FINAL REPORT

LIMITED ENERGY STUDIES

HOLSTON ARMY AMMUNITION PLANT
KINGPORT, TENNESSEE

CONTRACT DACA 01-91-D-0032
DELIVERY ORDER 0002 & 0003
EMC No. 3102-002

FIGURE 3-1. MASS AND ENERGY FLOW

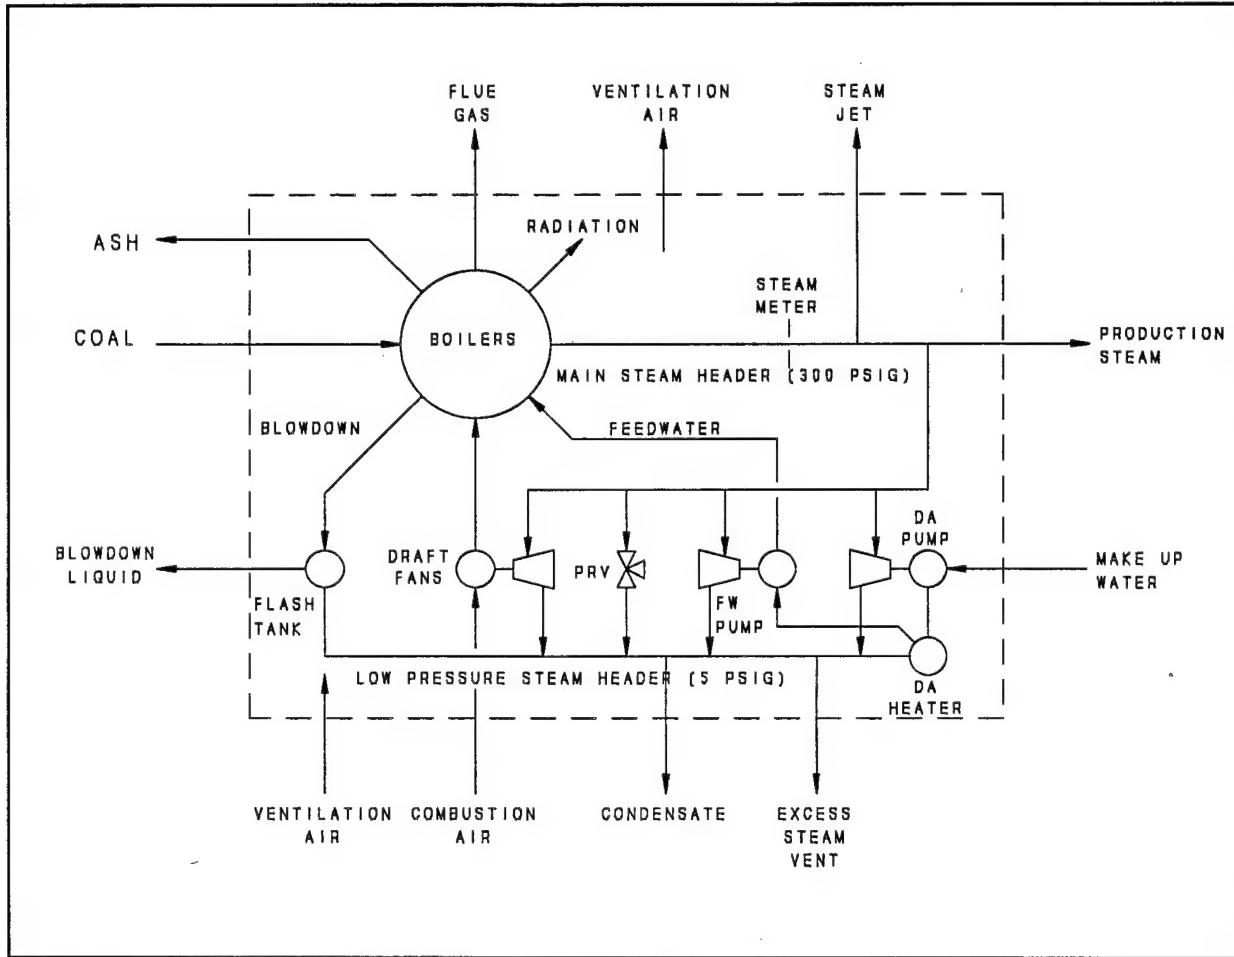
20. **Page 3-7:** Flow schematic is incorrectly referenced as Fig 3-2 on page 3-5. Please correct.

The flow schematic should reference Figure 3-1 on page 3-1. The report will be corrected.

FIGURE 4-1
AREA-B STEAM DISTRIBUTION
SYSTEM SCHEMATIC

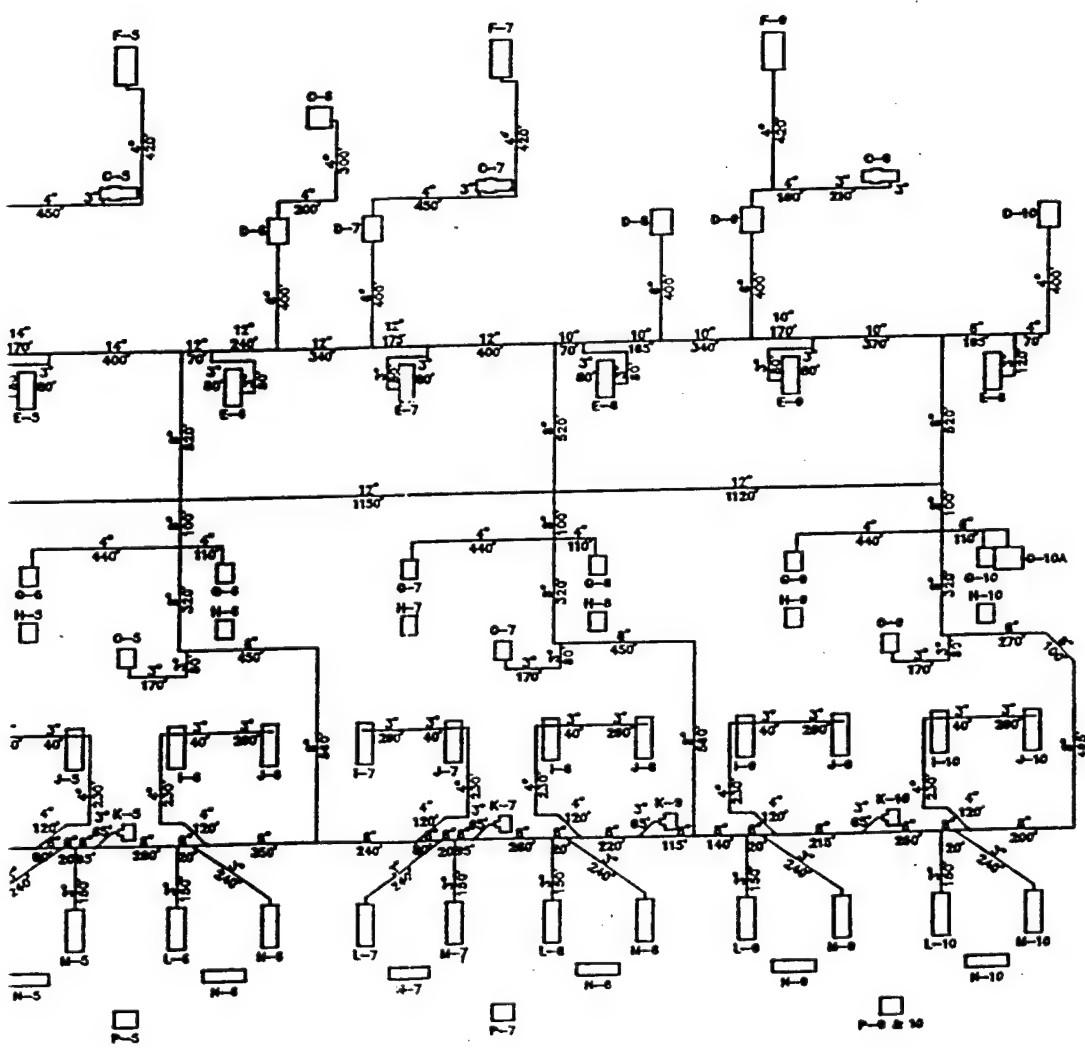
21. **Figure 4.1:** The PRV shown in the Administration Area is labeled "PRV 400/100 PSI"; shouldn't that be 300/100 PSI?

FIGURE 4-4. AREA-B BASE CASE STEAM LOAD

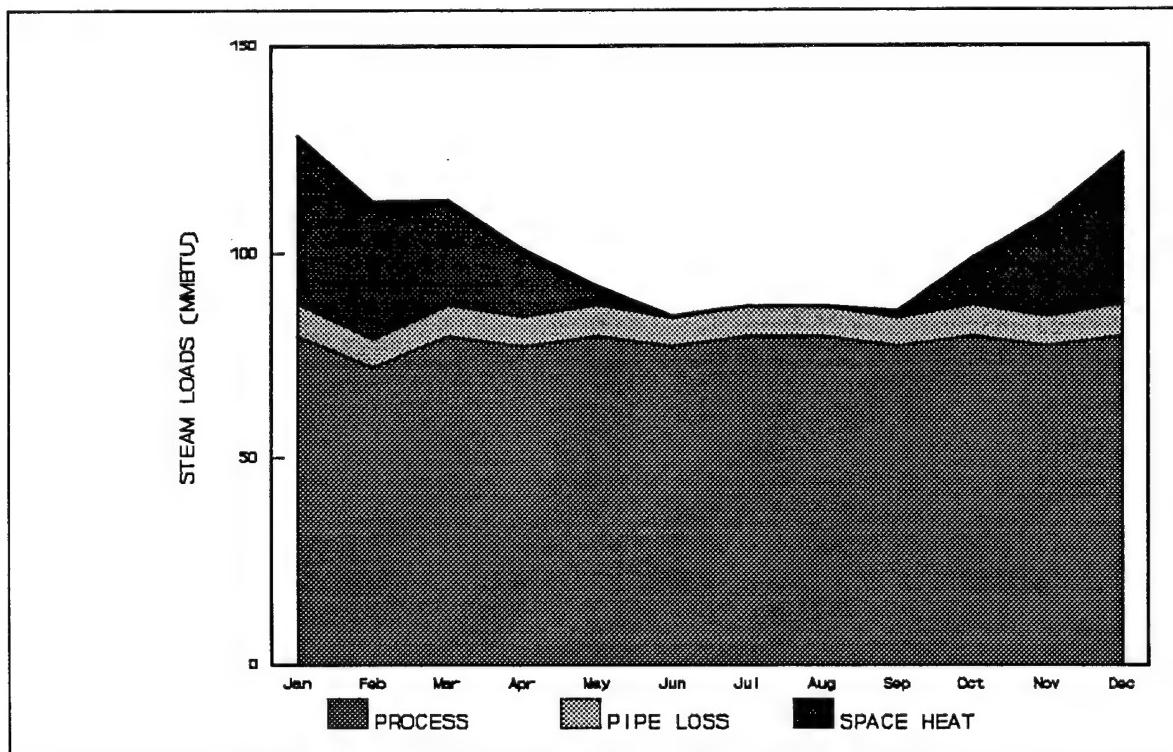
25. **Figure 4-4:** I would expect the piping heat loss to be greater in winter than in summer since the Delta-T would be greater, i.e., the dark band on the graph would be "skinnier" in June, July, and August than in December, January, and February. Please explain why it appears to be the same thickness throughout the year.

FIGURE 4-9. SYSTEM PIPING SCHEMATIC

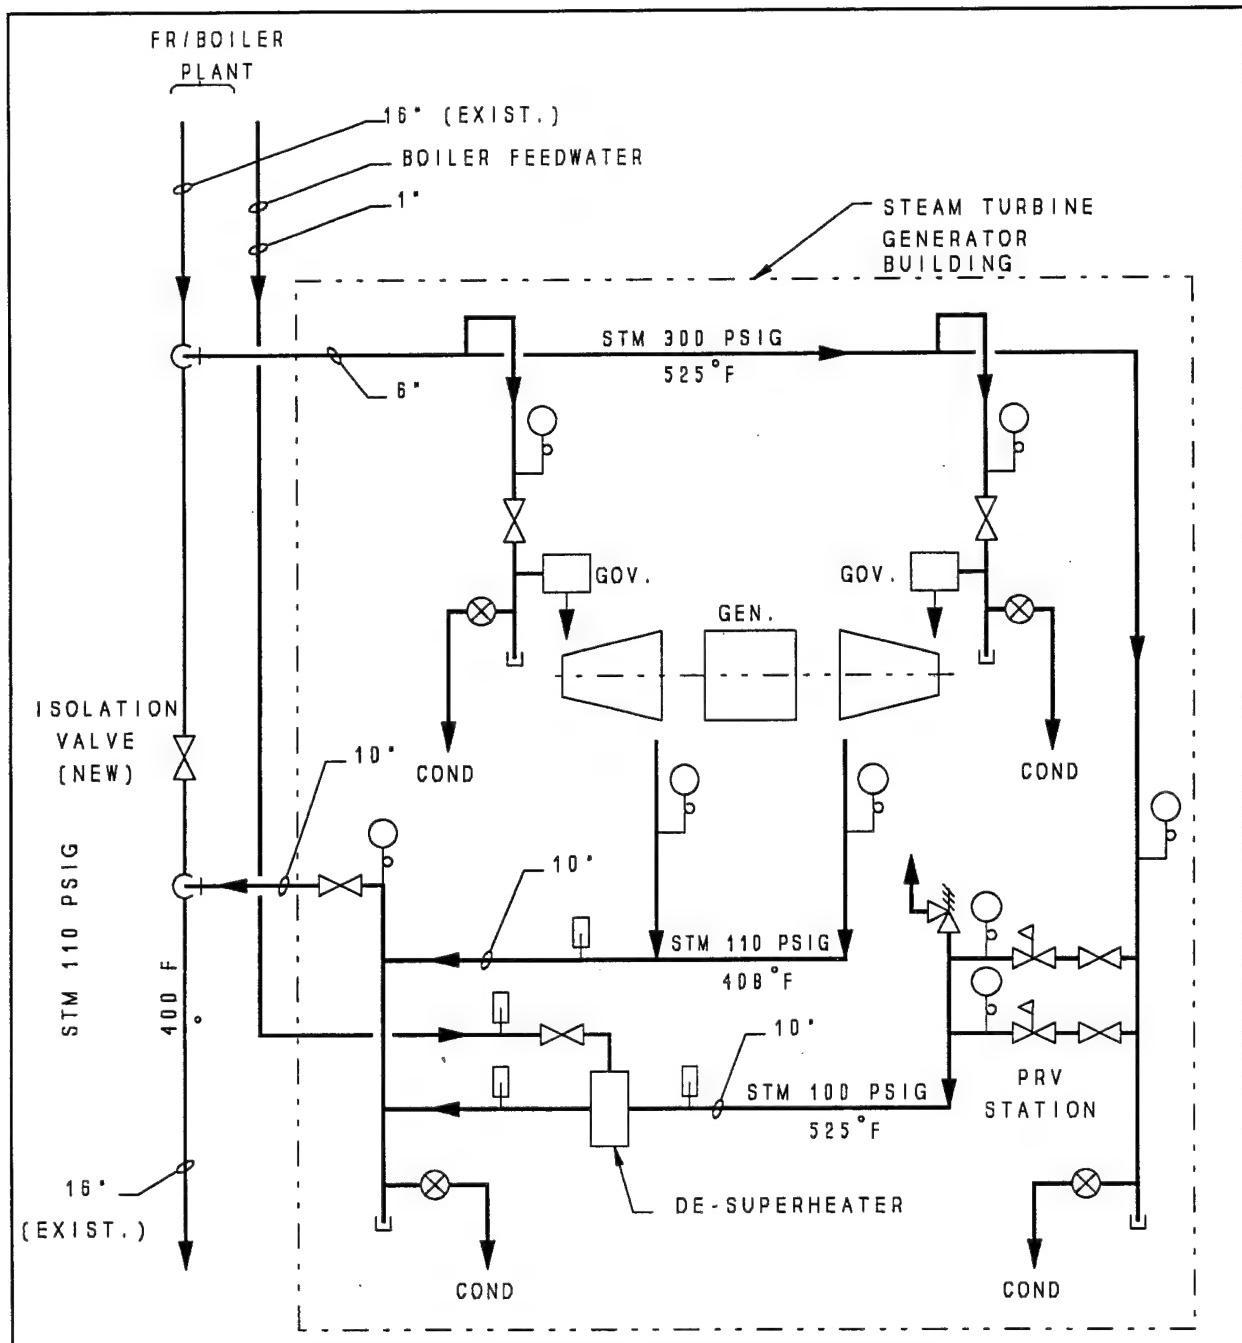
29. Page 4-18, 4-19, & 4-21: Resolve conflict regarding size of tie-in to existing boiler feedwater line. Figure 4-8 and Section 4.7.4.1 have it as a 1-inch line; but Figure 4-9 shows a 2-inch line.

The correct size of the tie in to the existing boiler feedwater line is 1". Figure 4-9 will be corrected to indicate a 1" feedwater tie in.

FIGURE 4-10. ELECTRICAL DISTRIBUTION SYSTEM TIE-IN

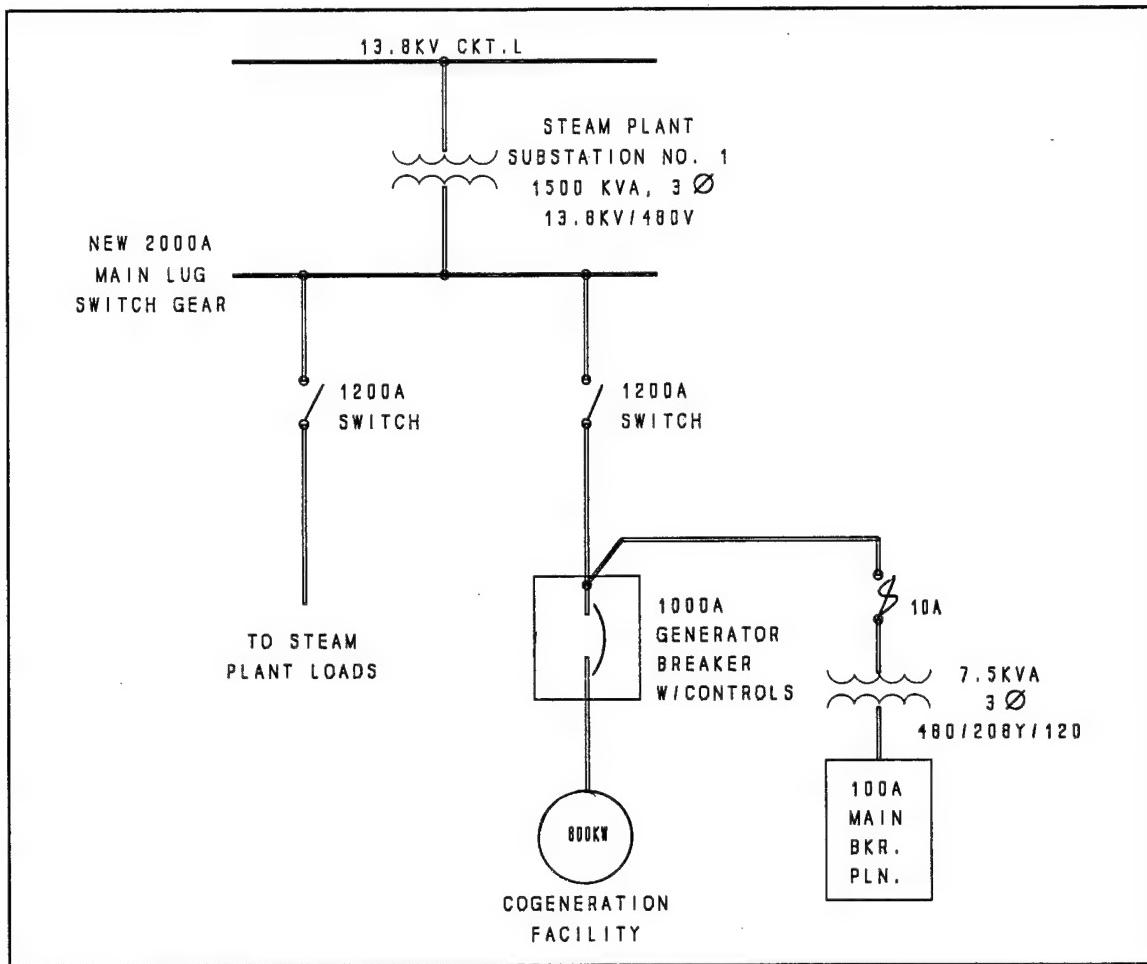
30. The last paragraph of Section 4.7.4.2 refers to Figure 4-8 on page 4-18; appears it should be Figure 4-10 on page 4-23.
